Access Compliance Report

Public Rights-of-Way

Intersection ID: 54697	Main Street: EXPO_DR	Cross Street: GIBBON_RD	Location: SW
ADA ID: DB8586F58AAC	Ramp Type: PerpDiag	Initial Pass/Fail: Pass	Overall Compliance: No
		Severity Score: 5.25

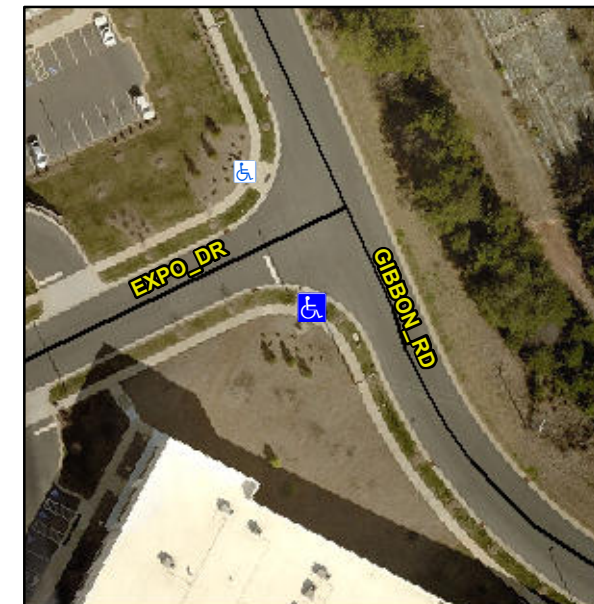
Not Found, R304.5.3, R304.5.4

Compliance	Description	Data	Compliance	Description	Data
N/A	Ramp Length (in)	96.5	Yes	Ramp Slope (%)	6.9
Yes	Ramp Width (in)	57.0	No	Ramp XSlope (%)	2.7
N/A	Flare Type LT	Sloped	N/A	Flare Type RT	N/A
N/A	Flare Slope LT (%)	6.2	Yes	Flare Slope RT (%)	9.9
N/A	Flare Traversable LT?	Yes	N/A	Flare Traversable RT?	Yes
Yes	Landing Length (in)	59.0	Yes	DWS Provided?	Yes
Yes	Landing Width (in)	61.0	Yes	DWS Contrast?	Yes
Yes	Landing Slope (%)	1.5	Yes	DWS Length (in)	24.0
Yes	Landing X Slope (%)	1.8	Yes	DWS Full Width?	Yes
N/A	Landing Curb? (Y/N)	No	Yes	DWS Offset (in)	1.5
N/A	Shared Landing?	No			
Yes	Gutter Ponding?	No	No	Gutter Slope (%)	6.0
Yes	Gutter Lip Ht (in)	0.0	Yes	Gutter X Slope (%)	1.9
N/A	Painted X Walk1?	No	N/A	Painted X Walk2?	No
	X Walk 1 Direction	To E		X Walk 2 Direction	To N
N/A	X Walk 1 Width (in)	N/A	N/A	X Walk 2 Width (in)	N/A
	X Walk 1 Slope (%)	0.7		X Walk 2 Slope (%)	1.7
	X Walk 1 X Slope (%)	2.3		X Walk 2 X Slope (%)	1.2

Remove & Replace Curb Ramp With Two New Directional Ramps or Equivalent. Remove & Replace Gutter.
